CITY OF WACO

Date: October 26, 2022
RFB No: 2022-081
Commodity: Operational Street Improvements (City Wide)
Contact: Paul Campos pcampos@wacotx.gov

Addendum No: 2

Operational Street Improvements (City-Wide) (18ST2201F, 18ST2202F)

**DEMOLITION PLAN & PROPOSED PLAN
HOOD STREET & ASHBURN STREET**

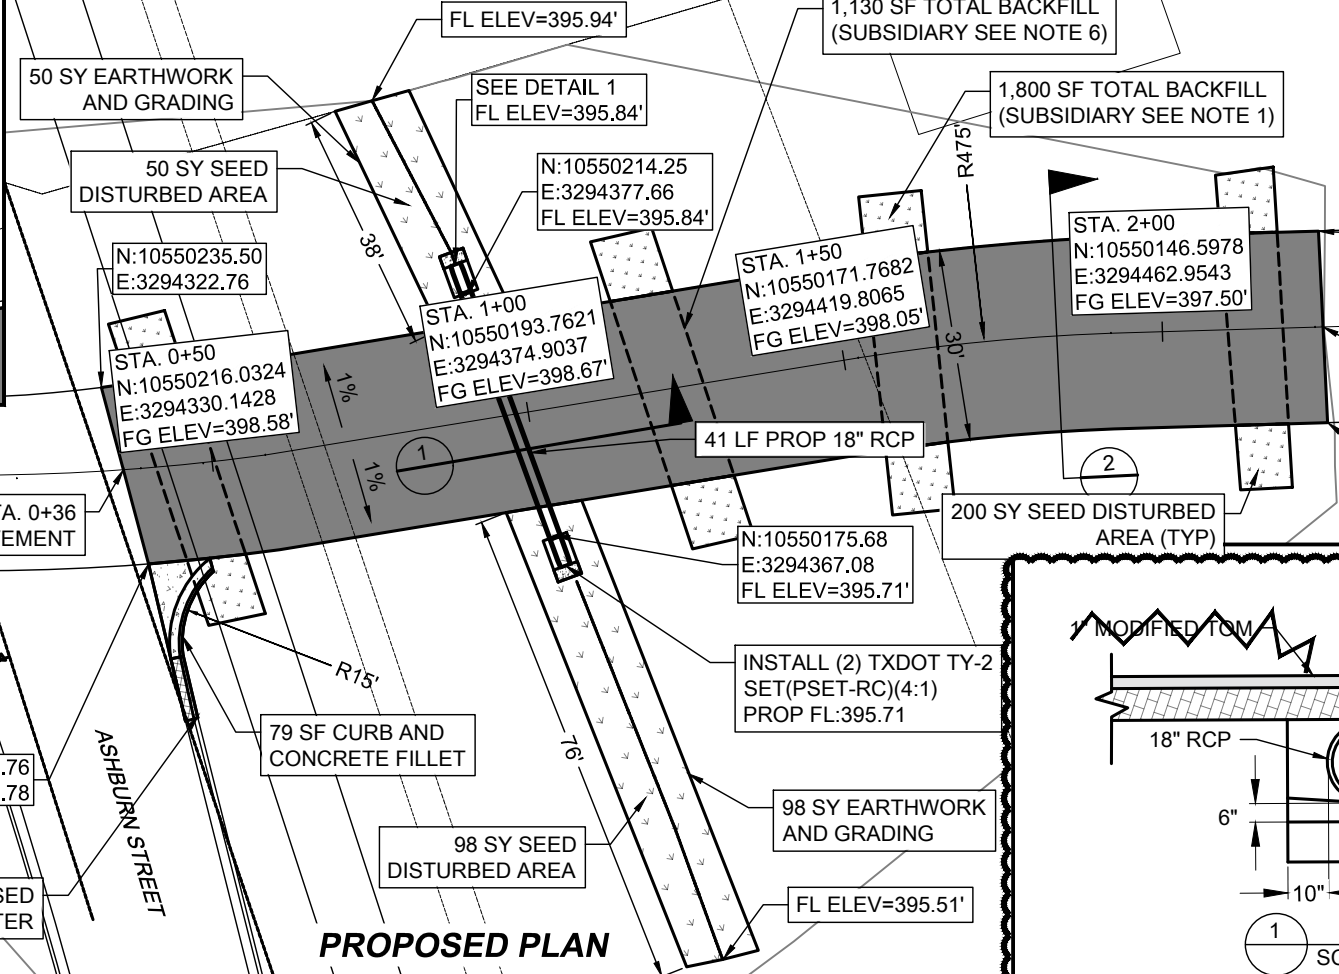
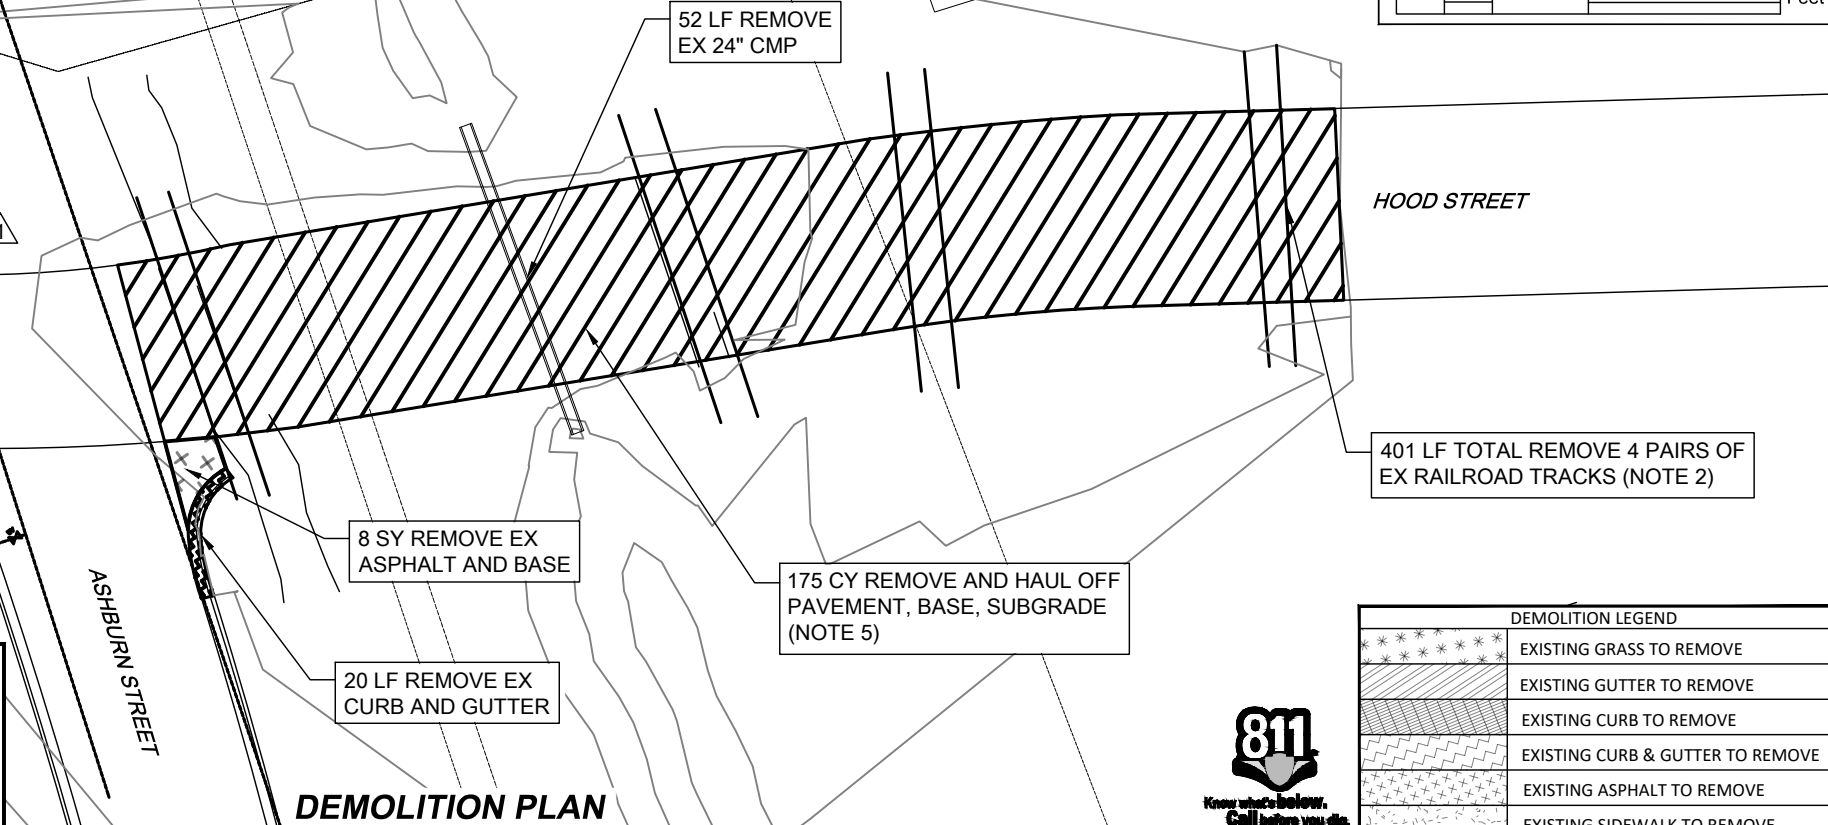
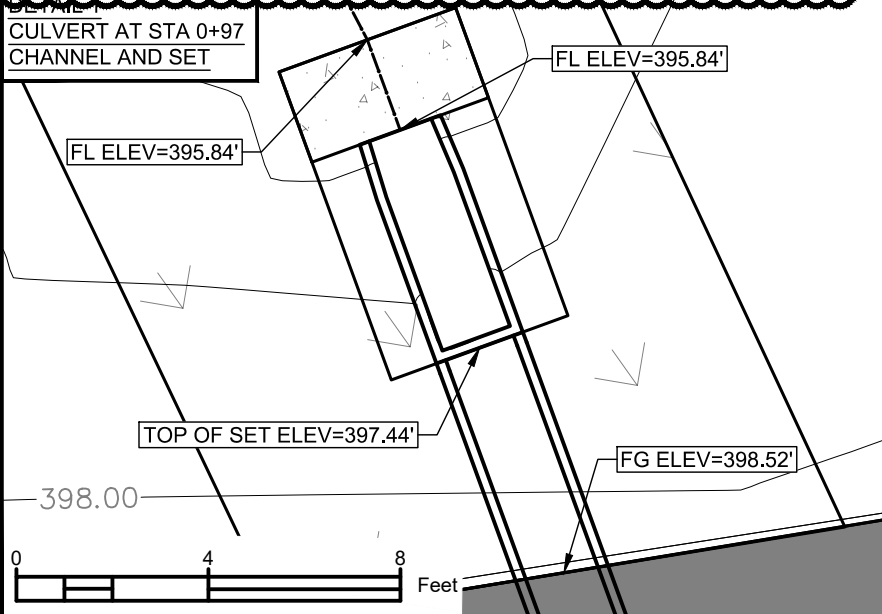
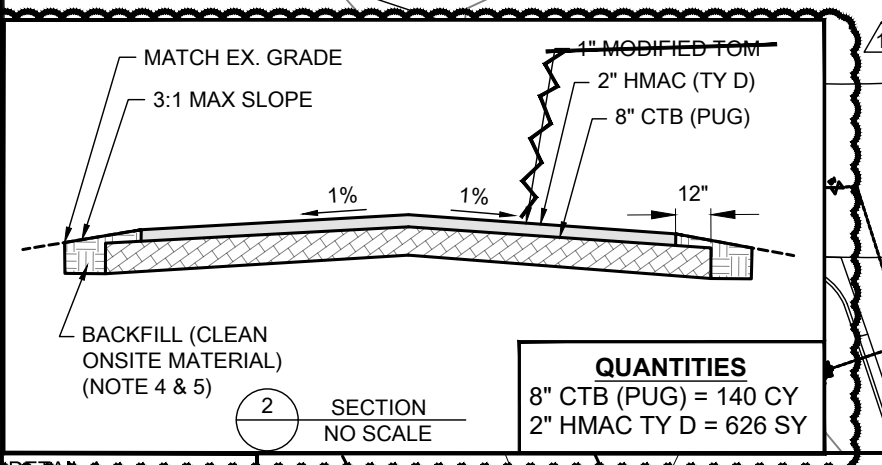
1. CONTRACTOR SHALL USE CLEAN, EXCAVATED MATERIAL TO BACKFILL RR TRACK REMOVAL TRENCHES UP TO 6 INCHES BELOW EXISTING GRADE. THE TOP 6 INCHES SHALL BE TOPSOIL. THIS WORK SHALL BE SUBSIDIARY TO THE RR TRACK REMOVAL BID ITEM.
2. REMOVAL SHALL INCLUDE TRACKS, TIES, CONCRETE APPROACHES, AND ANY OTHER DELETERIOUS MATERIAL ASSOCIATED WITH THE RR TRACKS.
3. FOUNDATION COURSE (AS REQUIRED) TO PROVIDE FIRM, STABLE, AND UNIFORM PIPE SUPPORT PER STANDARD SPECIFICATIONS FOR CONSTRUCTION, SECTION 4.2, PART 2.A.2a COURSE CRUSHED ROCK. ALTERNATIVE ROCK SIZES SHALL BE PRE-APPROVED BY CITY ENGINEER.
4. CLEAN MATERIAL MAY BE USED TO BACKFILL EDGES OF ROAD.
5. SUBSIDIARY TO CTB BID ITEM.
6. CONTRACTOR SHALL USE CLEAN, EXCAVATED MATERIAL TO BACKFILL RR TRACK REMOVAL TRENCHES UP TO THE BOTTOM OF THE PROPOSED 8" CTB LAYER. THIS WORK SHALL BE SUBSIDIARY TO THE RR TRACK REMOVAL BID ITEM.
